Final Environmental Impact Report

# Vallco Special Area Specific Plan

SCH# 2018022021

August 2018

Figure 8: Vallco Specific Plan Process Alternatives to Date (self)

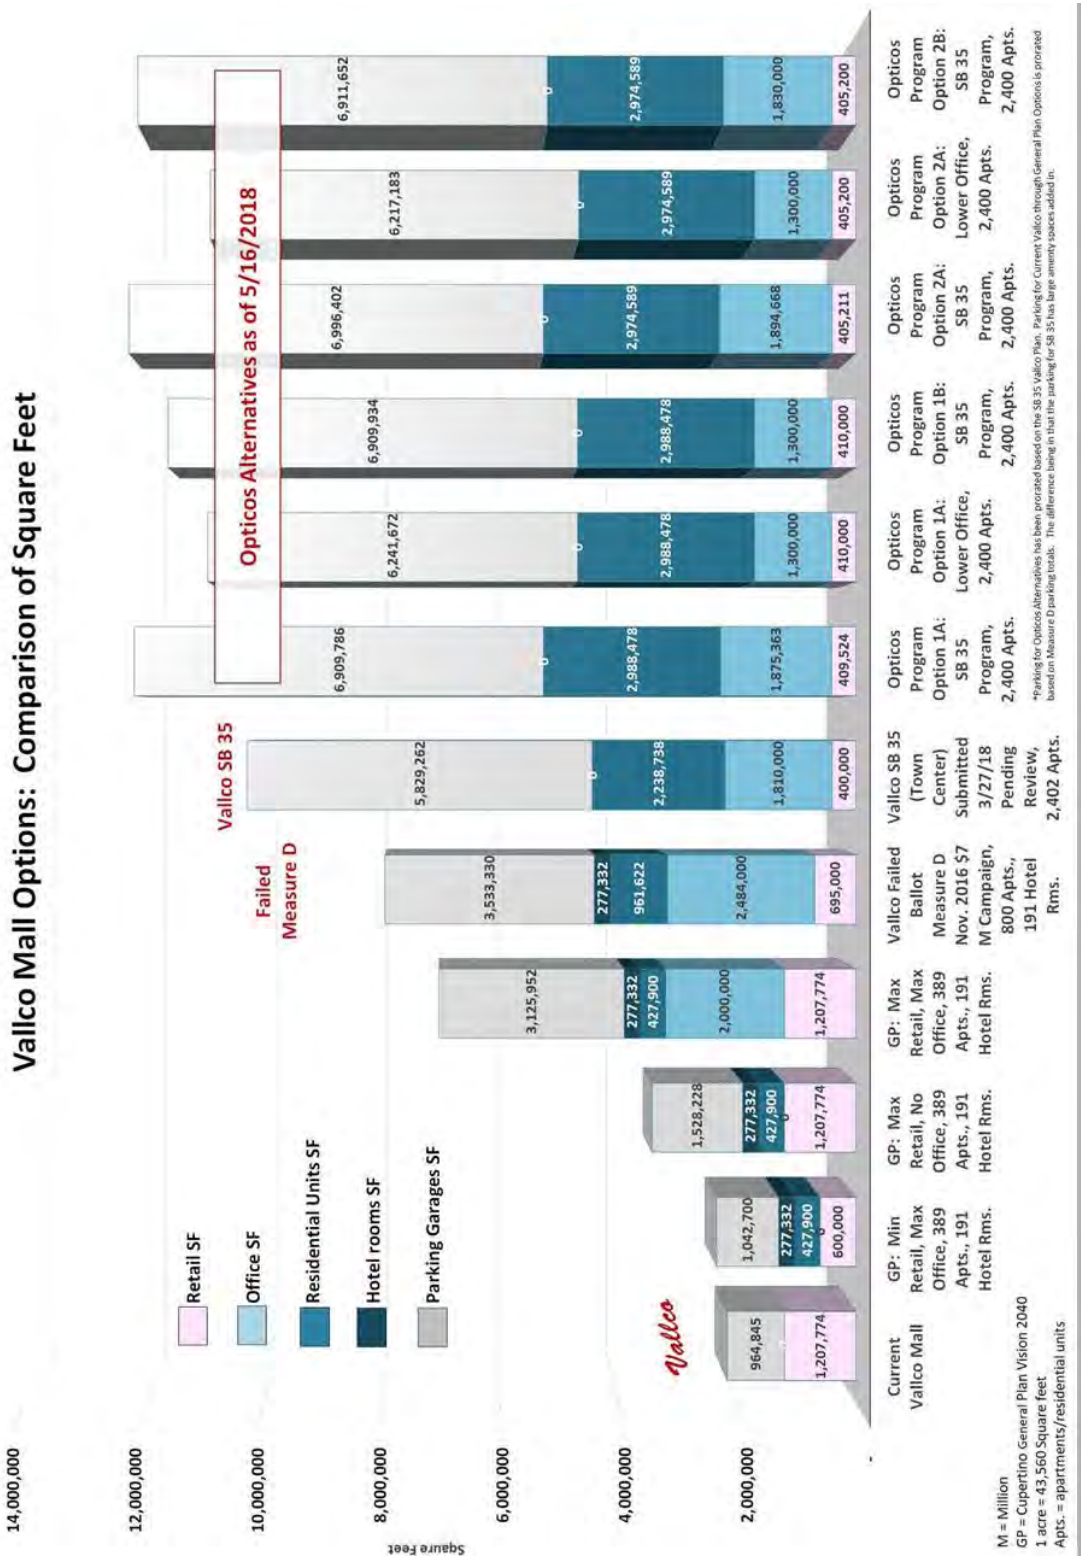
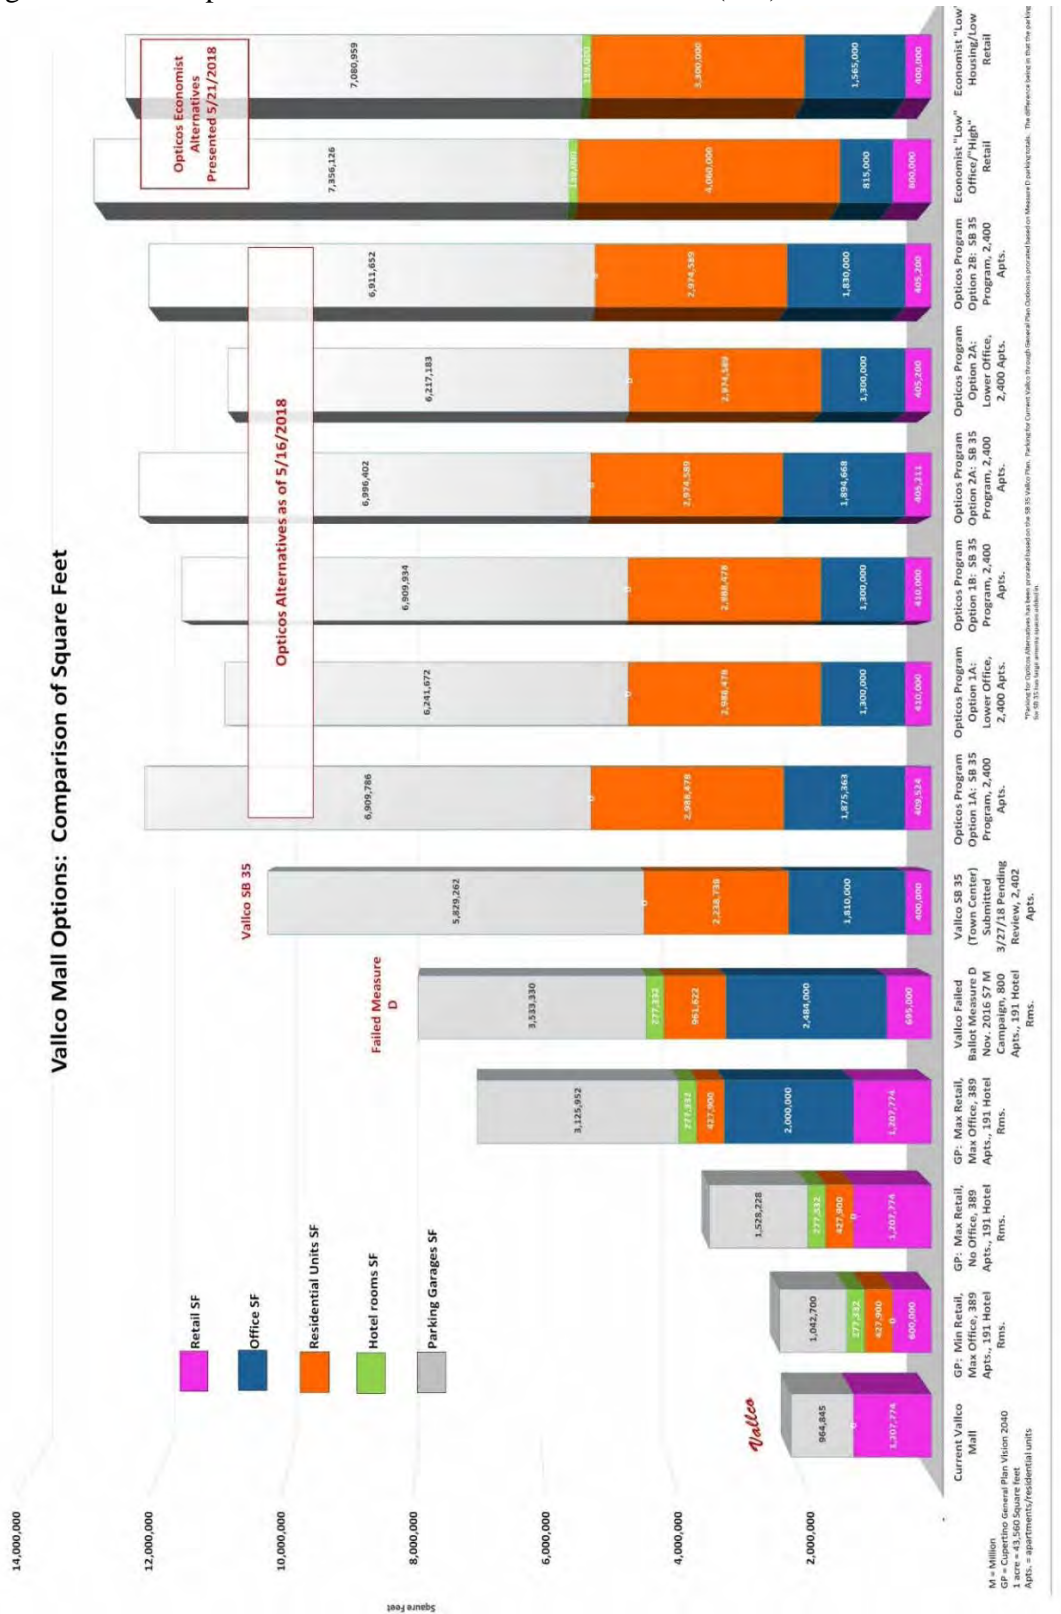
Figure 7: Vallco Project Alternatives after Charrette #1 (self)

**Response O.23:** Refer to Section 5.2 Response II.E.19.

Figure 9: Cupertino General Plan

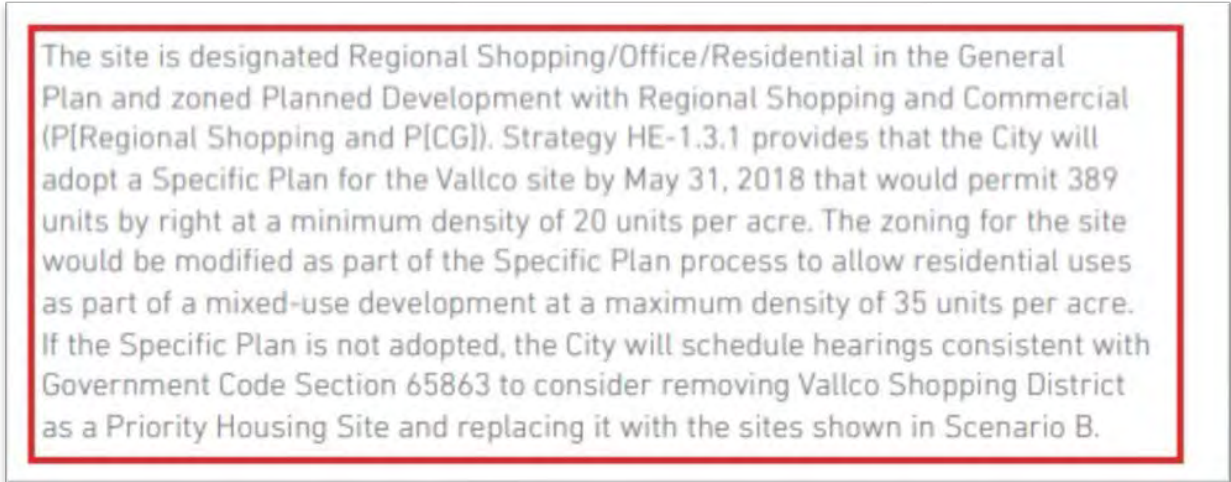
This section fails to state the current zoning designations per the General Plan, no Specific Plan has been adopted:

**Response O.25:** Refer to Section 5.2 Response II.E.21.

Figure 25: AQI from BAAQMD

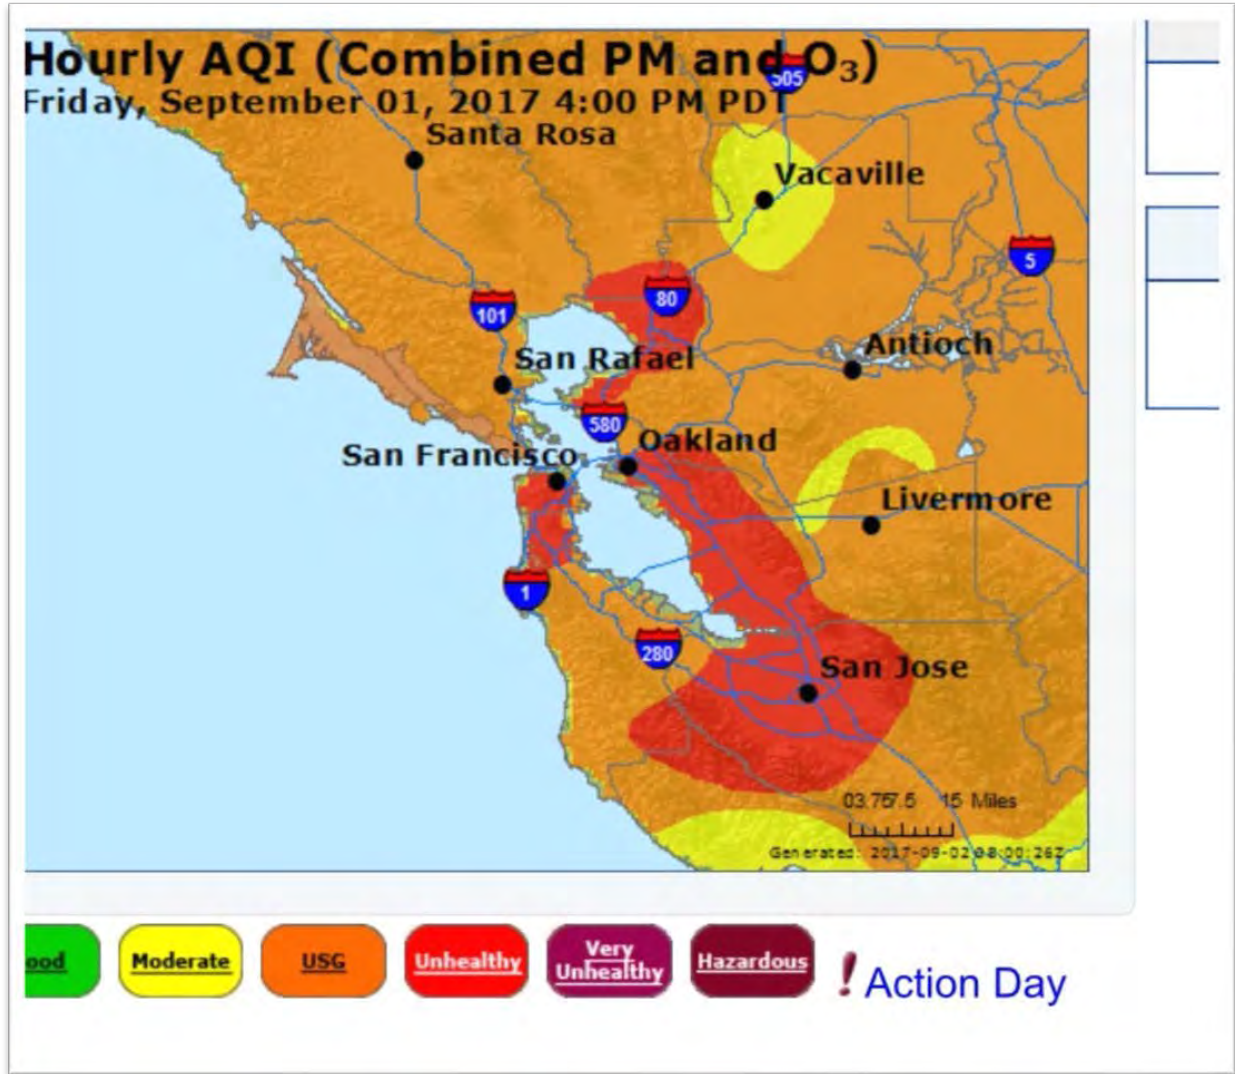
baseline air quality monitoring must be taken over an extended period with particular attention paid to the summer months when Ozone levels increase. Here is an example day when children would be playing outdoors, Ozone was the primary pollutant. Note these are regional amounts, and the increases along the freeways are not shown:

**Response O.57:** Refer to Section 5.2 Response II.E.53.

Figure 42: Opticos Charrette #2

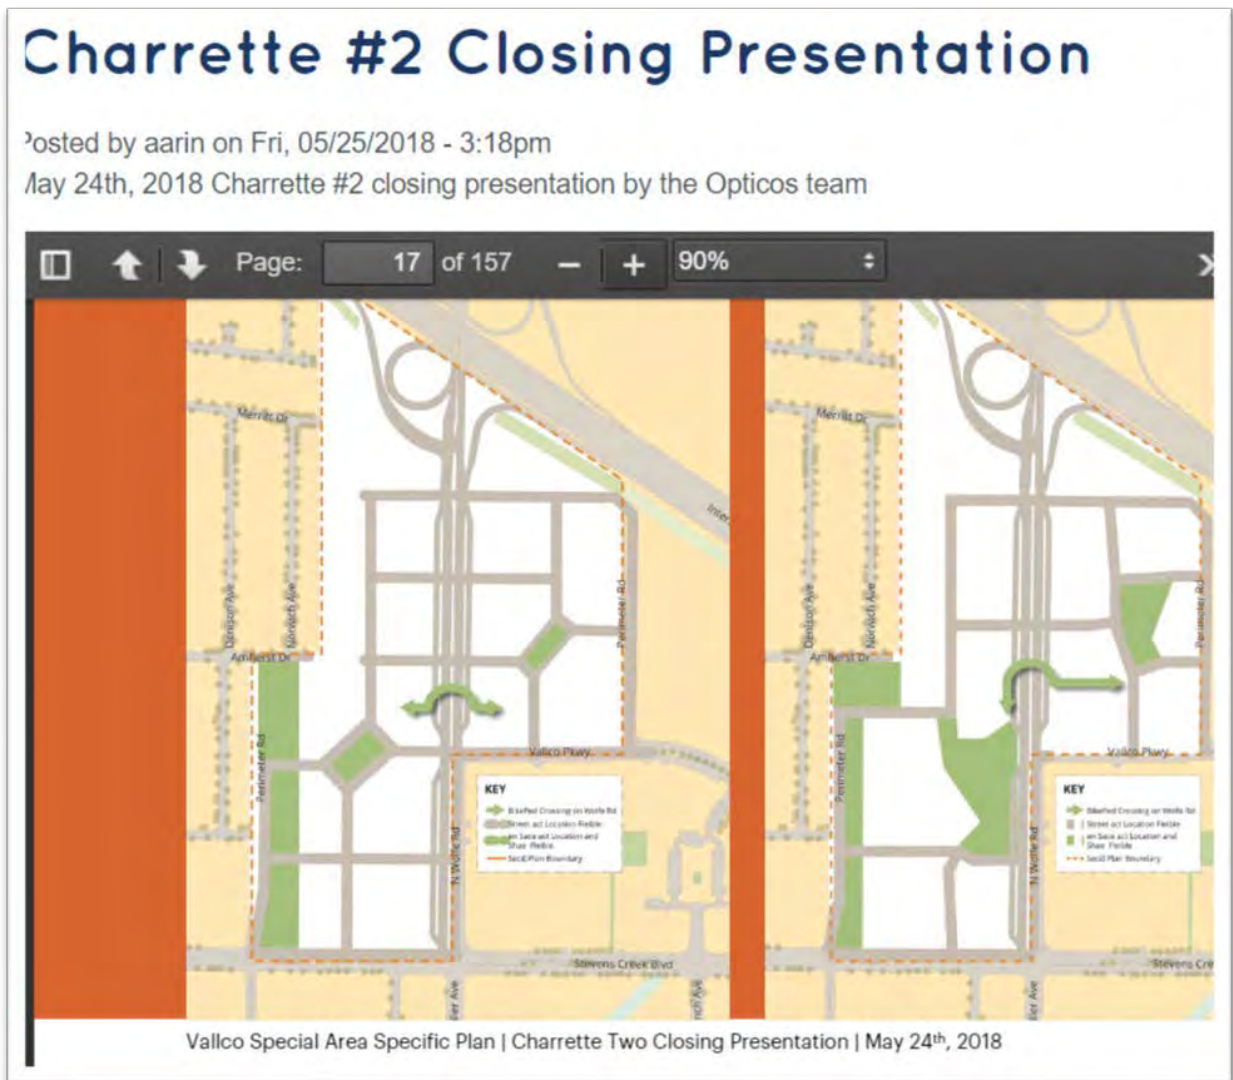
Charrette #2 Closing Presentation shows parks adjacent to back yards of single family residences. This may, combined with Perimeter Rd. noise exceed Municipal Code permissible sound levels. The DEIR does not adequately address this.

**Response O.109:** Refer to Section 5.2 Response II.E.105.
